## Proposed Residential Development Located South of Darton Lane, Staincross, Barnsley

Stage I Road Safety Audit

May 2024

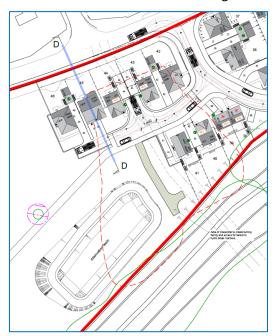
**Location:** Side road junctions and pedestrian desire lines throughout the site and on Darton Lane

**Summary:** Risk of pedestrians tripping/falling over full height kerbs and sustaining injury due to absence of crossing facilities at side road junctions and main desire lines

No crossing facilities for pedestrians (e.g. dropped kerbs and tactile paving) are shown across side road junctions or across Darton Lane to serve key desire lines. The absence of these facilities may increase the risk of pedestrians tripping/falling over full height kerbs as they attempt to cross, and sustaining injury as a result. The absence of such facilities is also likely to make it difficult for elderly pedestrians and those with mobility/visual impairments to navigate the site and nearby services such as shops, schools and public transport.

It is recommended that on-desire line pedestrian crossing points consisting of dropped kerbs and tactile paving are provided across relevant junctions and at pedestrian desire lines.

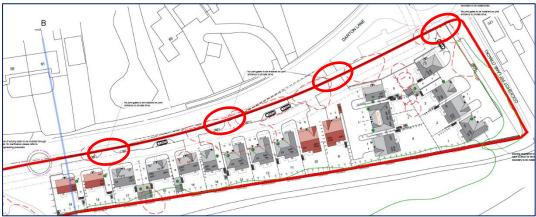
Location: Proposed shared drive accesses from Darton Lane

Summary: Risk of Failure to Give Way (FTGW) collisions and vehicle / pedestrian conflicts

The site topography means that the proposed shared drive accesses abut the Darton Lane footway at a significant gradient. It is also unclear as to whether the existing brick retaining wall alongside Darton Lane will be retained. These arrangements could result in a number of road safety related issues:

- The proposed falls into the site if excessive, would increase the risk of pedestrian slips,
- An excessive approach gradient could increase potential for FTGW type collisions for vehicles exiting shared drives; and
- The existing wall at the rear of footway may impair visibility splays for vehicles exiting shared drives increasing the risk of FTGW type collisions and vehicle / pedestrian conflict.

It is recommended that the proposed shared drive accesses are designed with appropriate gradients and visibility splays.

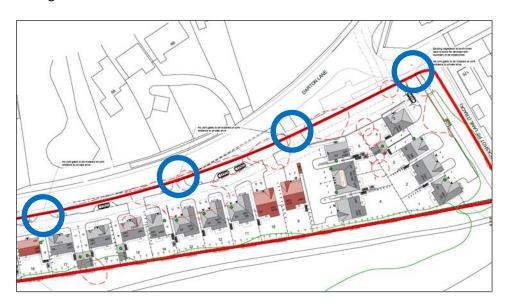
Location: Proposed shared drive accesses from Darton Lane ed s38 Street

**Summary:** Risk of vehicle/vehicle collisions due to vehicles waiting at the gates protruding into Darton Lane

At the four shared drive accesses from Darton Lane, drawing annotations state that 'no joint gates to be installed on joint entrance to private drive'. It is unclear what 'no joint gates' are and how they would operate, but they appear to be located at the back of the Darton Lane footway. As such, a driver waiting to enter the site at the gates is likely to protrude into the westbound traffic lane whilst waiting for the gates to open, thereby increasing the risk of collision with westbound vehicles on Darton Lane.

It is recommended that either gates are not provided at the shared drives, or if they are provided that they are set sufficiently far back from Darton Lane so that a waiting vehicle does not protrude into the Darton Lane carriageway.
